NINE MILE POINT NUCLEAR STATION, UNIT NO. 1

AMENDMENT TO FACILITY OPERATING LICENSE

Amendment No. 36
License No. DPR-63

ATTACHMENT TO LICENSE AMENDMENT NO. 36

Figure 3.1.7.aa LIMITING POWER FLOW LINE

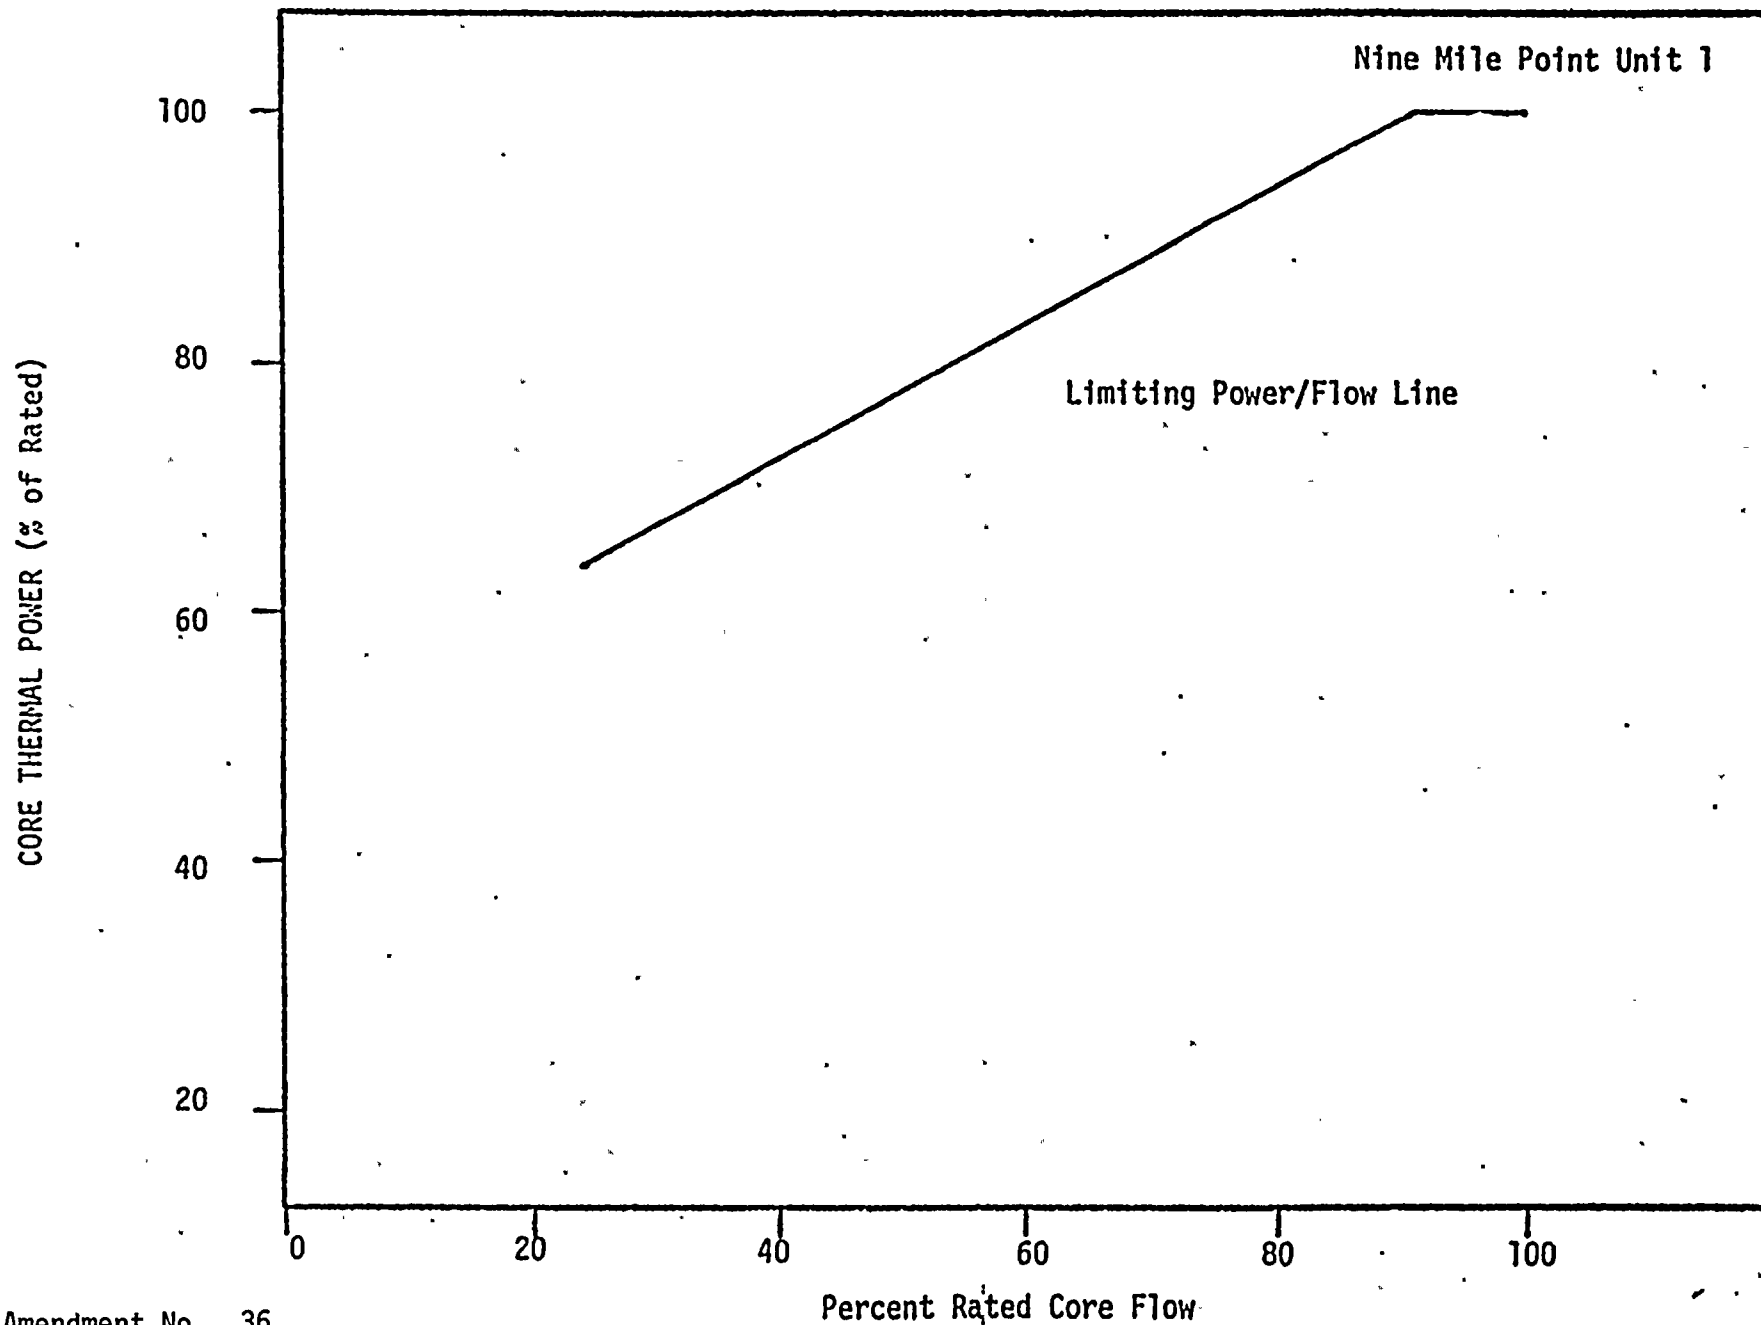
The power/flow curve is the locus of critical power as a function of flow from which the occurrence of abnormal operating transients will yield results within defined plant safety limits. Each transient and postulated accident applicable to operation of the plant was analyzed along the power/flow line. The analysis (7,8,9) justifies the operating envelope bounded by the power/flow curve as long as other operating limits are satisfied. Operation under the power/flow line is designed to enable the direct ascension to full power within the design basis for the plant.
